Docket Item # 2  
BAR CASE # 2010-0116

BAR Meeting  
June 16, 2010

**ISSUE:** Alterations  
**APPLICANT:** Fred L Brewer  
**LOCATION:** 416 North Union Street  
**ZONE:** RM / Residential

Figure 2. Proposed front elevation

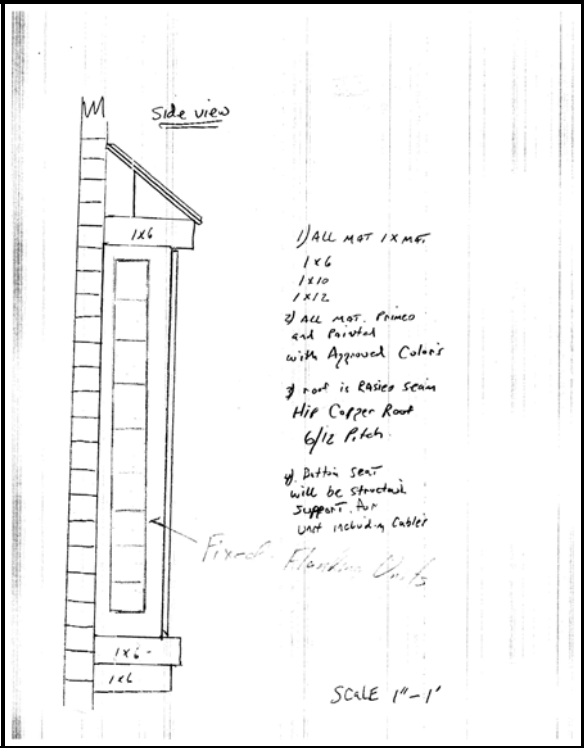
While staff generally discourages the replacement of true divided light windows with simulated divided light windows, in this situation due to the desire for the new window to have the same muntin profile as the remaining windows on the façade, staff believes the use of simulated divided lights would be appropriate.

Because the houses in this development along North Union have a variety of bay windows of differing styles and because the Board has approved bay windows extremely similar if not identical to the one proposed in this application, Staff recommends approval of the proposed bay window.

**STAFF RECOMMENDATION:** Staff recommends approval of the application as submitted.
